U.S. Department Of Transportation Federal Highway Administration

March 31, 1989

Refer to: HNG-14/SS-08

This is in response to your February 17 letter to Mr. James H. Hatton requesting Federal Highway Administration (FHWA) acceptance of single and dual support installations of your company's Telespar Highway Sign Posts. You enclosed copies of the report Full-Scale Mini-compact Vehicle Tests on Telespar Sign Supports in Strong and Weak Soil and Addendum dated August 1987, and September 1988, respectively.

Figure 5
SIGNPOST INSTALLATION DETAILS

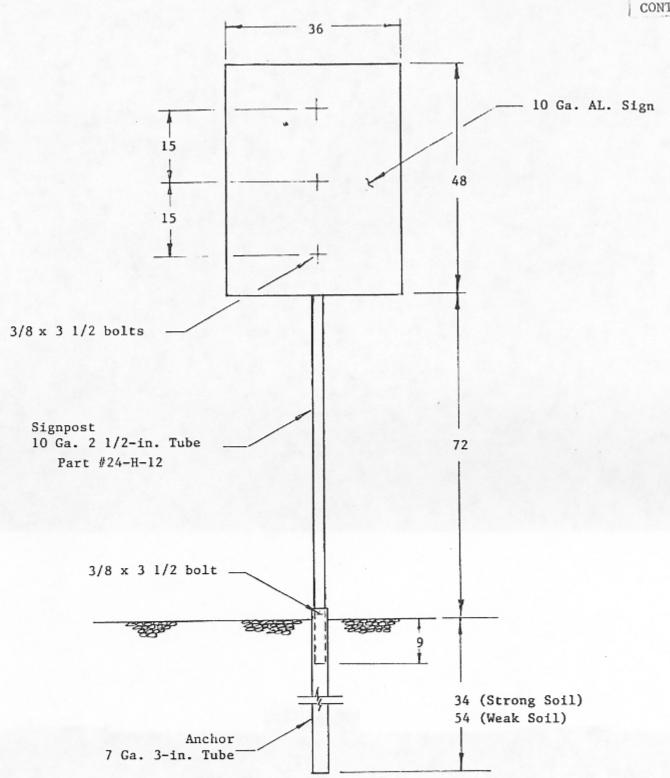
The support system consists of perforated square steel tube sign supports inserted into and bolted to larger tubes driven to within approximately 1 ½ inches of the ground surface. Tube sizes and gauges vary depending on sign loading requirements.

Based on the above information, we conclude that the tested system, as well as the system using A570 steel, meets the breakaway requirements of both the 1975 and the 1985 editions of the American Association of State Highway and Transportation Officials (AASHTO) "Standard Specifications for Structural Supports for Highway Signs, Luminaires and Traffic Signals." Therefore, the system is acceptable for use on Federal-aid highway projects within the range shown below for both strong and weak soils, if proposed by a State.

Post No.	Size Inches	Gauge	Number Permitted Within 7-foot Path
24H12	2 ½	10	1
21H12	2 3/16	10	1
24F12	$2^{1/2}$	12	1
22F12	2 1/4	12	1
20F12	2	12	2
16F12	1 3/4	12	2
14F12	1 ½	12	2

This acceptance is limited to breakaway characteristics of the system described above and does not cover its structural features. Presumably, Unistrut Corporation will supply potential users with sufficient information on structural design and installation requirements to ensure proper support performance.
